SERVICEORDRE – 2013-3

| FORMÅL: | Kontrollere at lengden på kuttkablene er korrekte. |

SERVICE BULLETIN SPSB008

SUBJECT: RELEASE CABLE TRIMMING

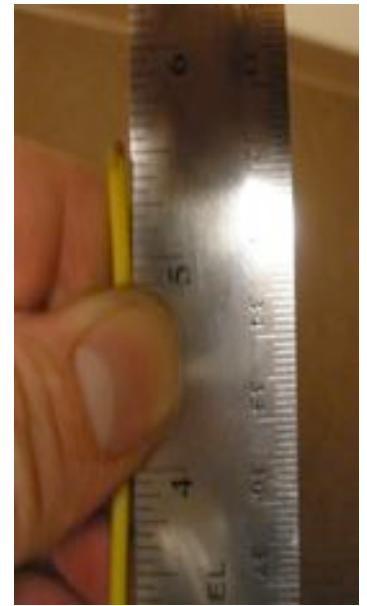
2. Ensure that the release handle is installed; Velcro mated and is all the way up to the top of the inside of the pocket.

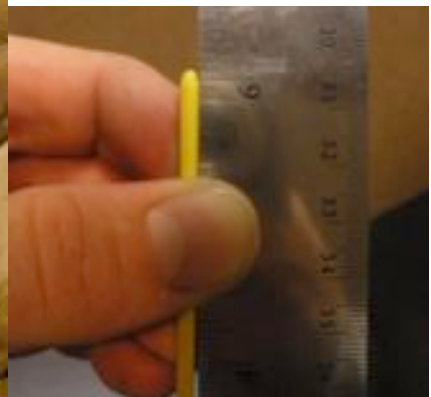
3. Remove any slack in the cables by pulling upward on both sides slightly. (A short tug/or pull on the cable end should take out any slack that may be in the system)
4. Place the rig on the ground or chair and allow the yoke area to relax and ensure your housings are seated/routed as if being worn. Specifically the loop area on the left side behind the main ring cover.
